ADDENDA – A-01

.1 Bids in accordance with the Drawings and Specifications included with these Bid Documents for:
Fort St. John Hospital – Residential Care Cooling Upgrade.

PROJECT:
**FORT ST. JOHN HOSPITAL
RESIDENTIAL CARE COOLING
UPGRADE**

<p>301D - 30721 Simpson Road, Abbotsford, BC</p>	Curb at Roof	DATE Dec. 11 / 2023	SEAL
		SCALE 3" = 1'-0"	
		DWN. SK	
		CH'D. SK	DWG. #
		PROJ. #	
EGBC PTP 1000190

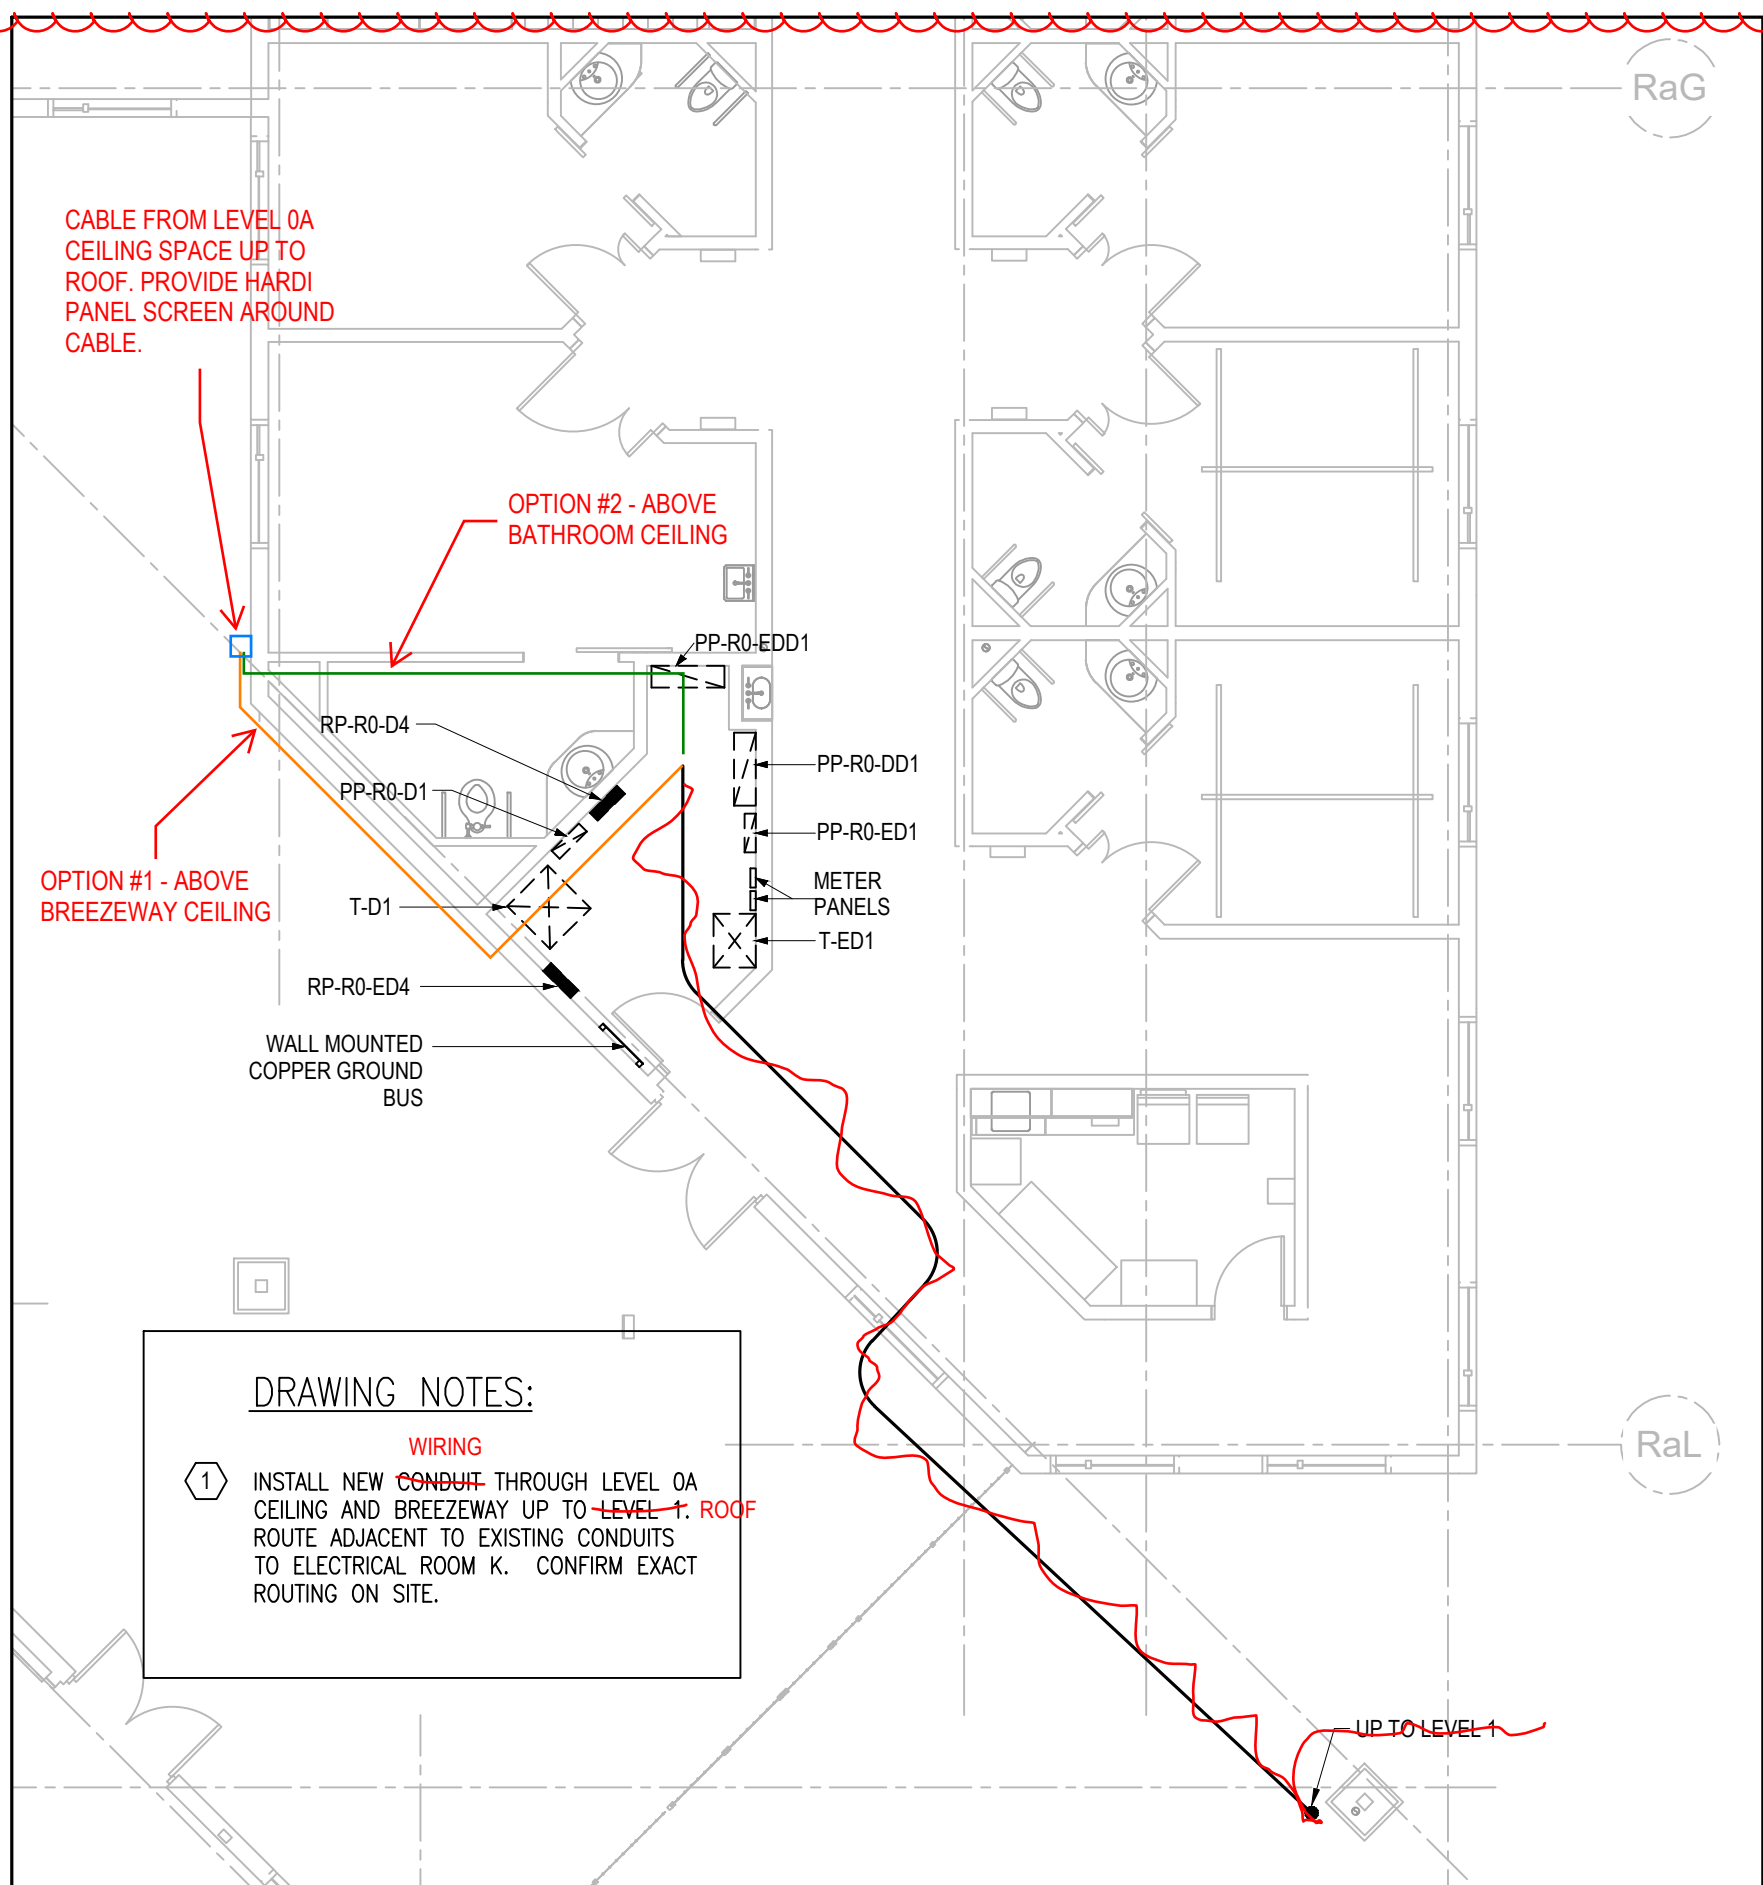
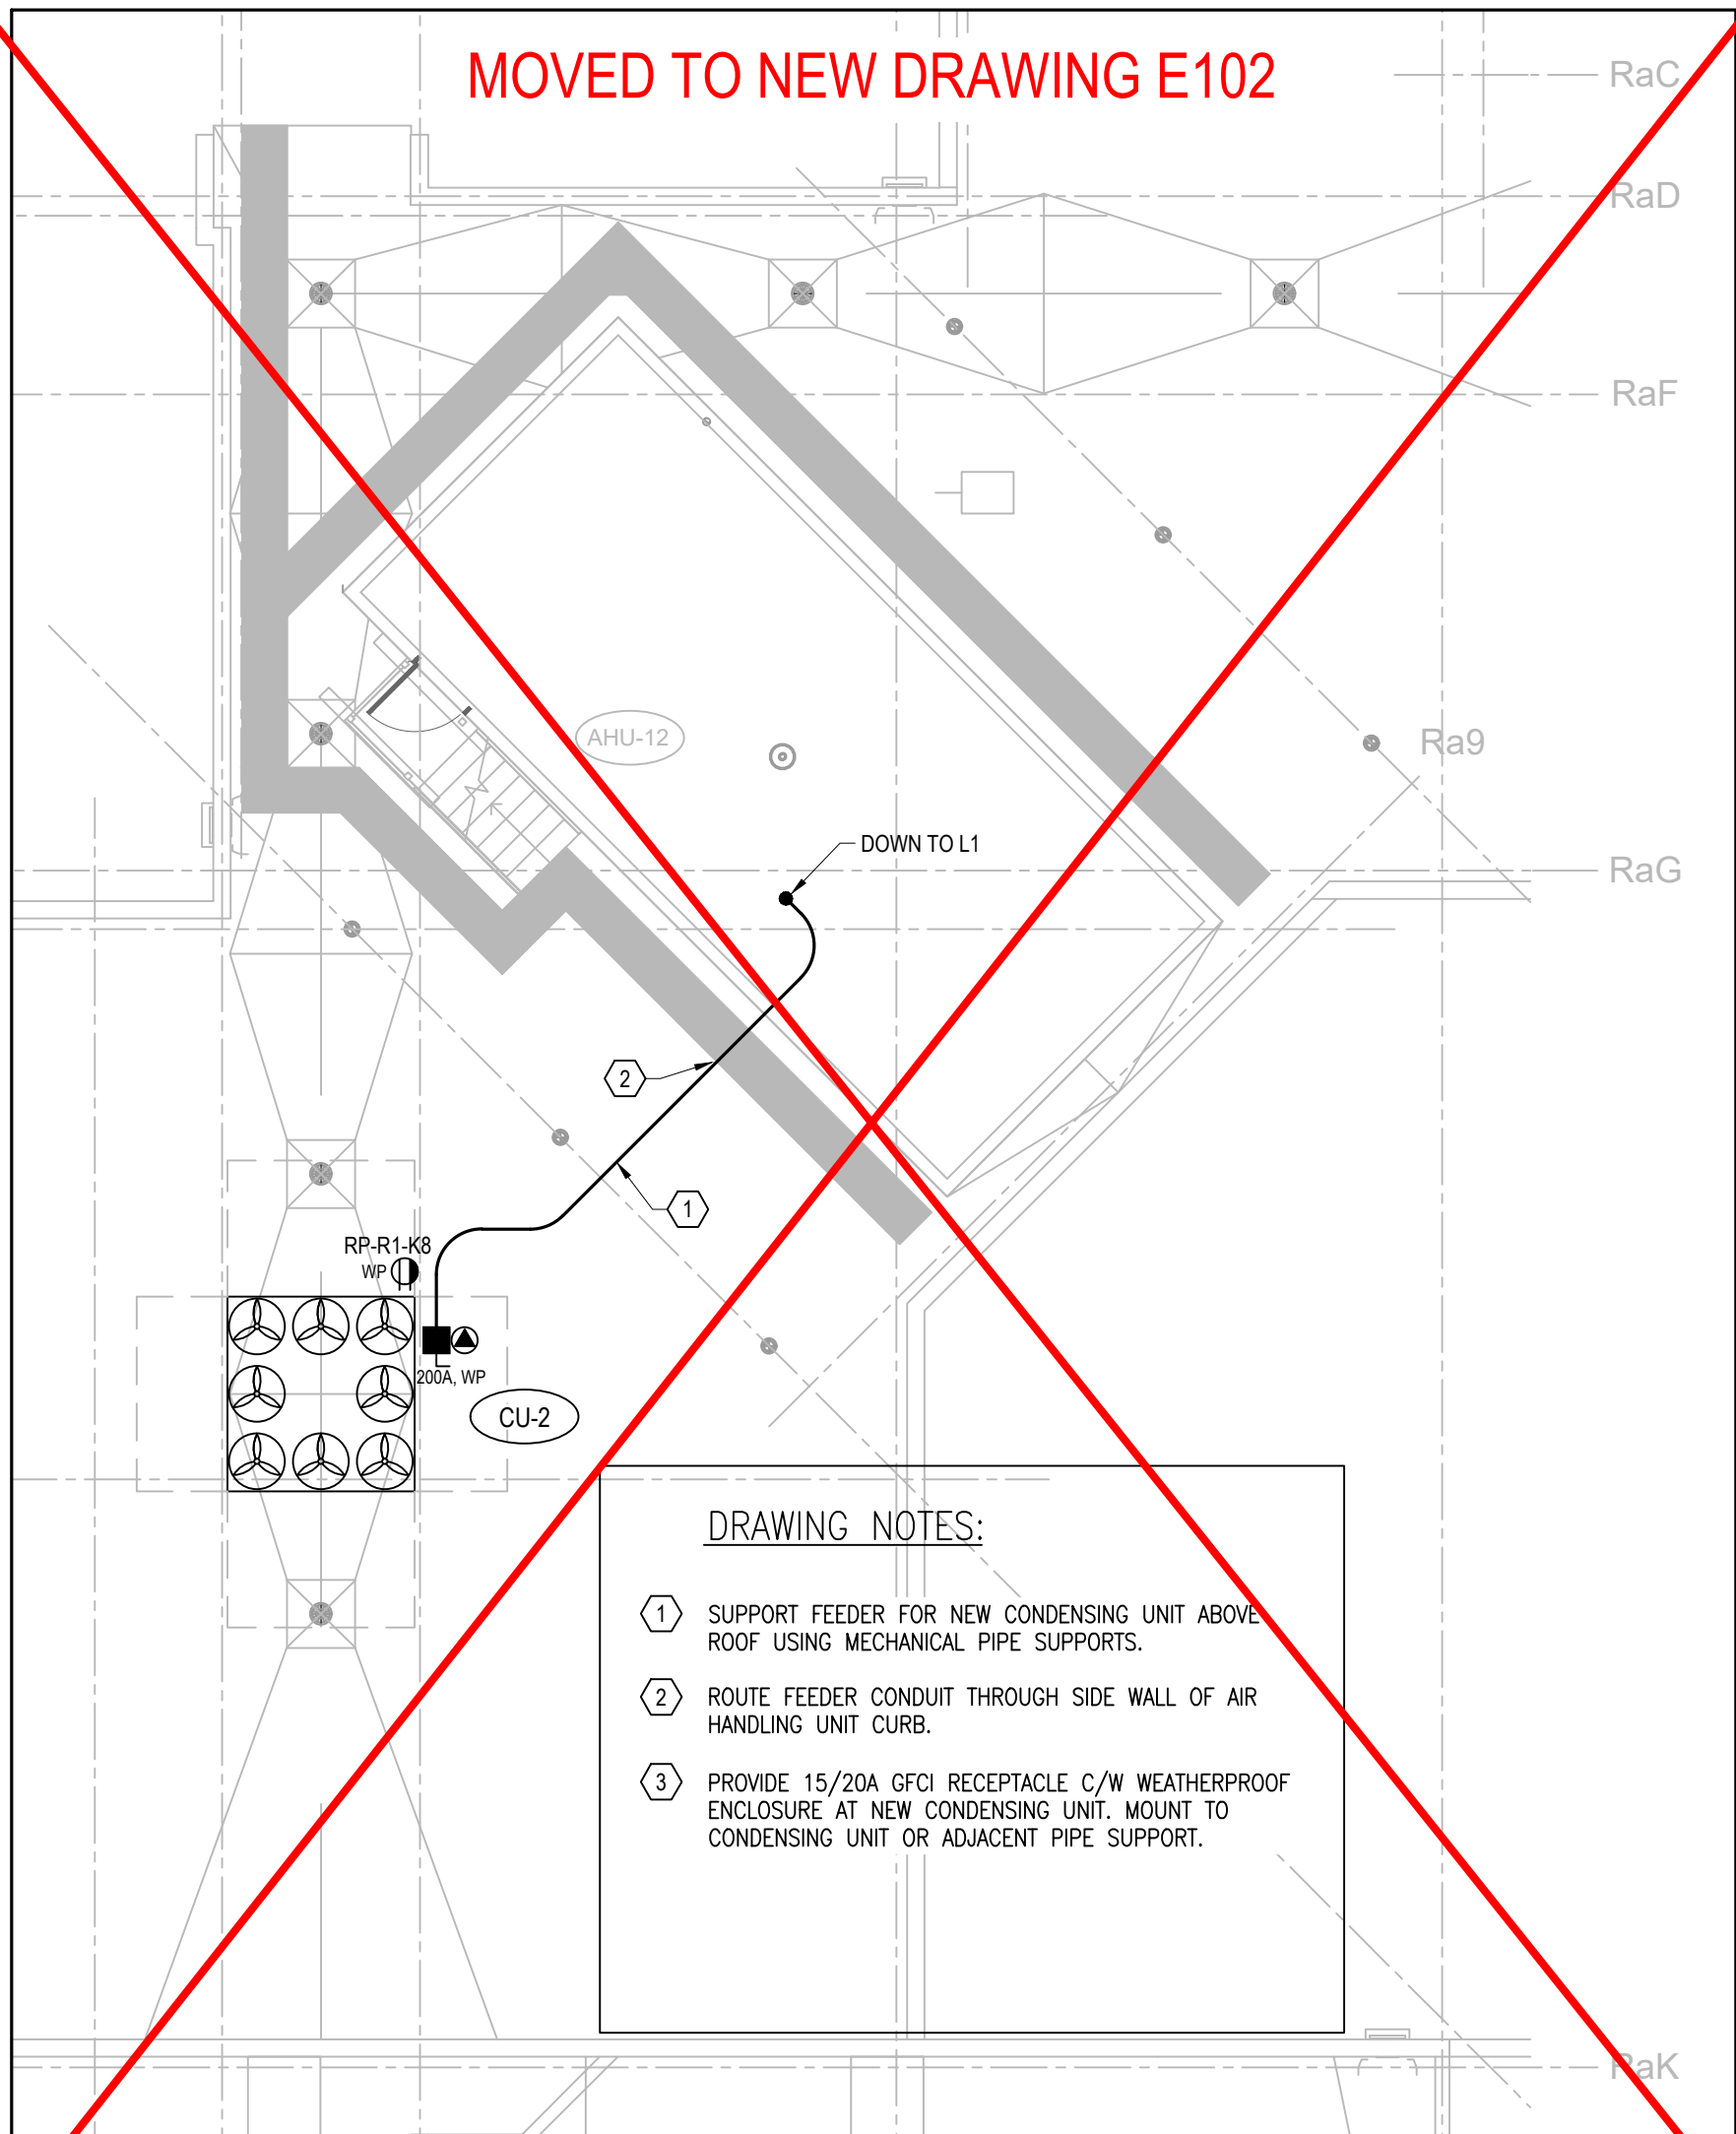
2.1 SK – CURB AT ROOF

.1 Add sketch “SK - Curb at Roof”
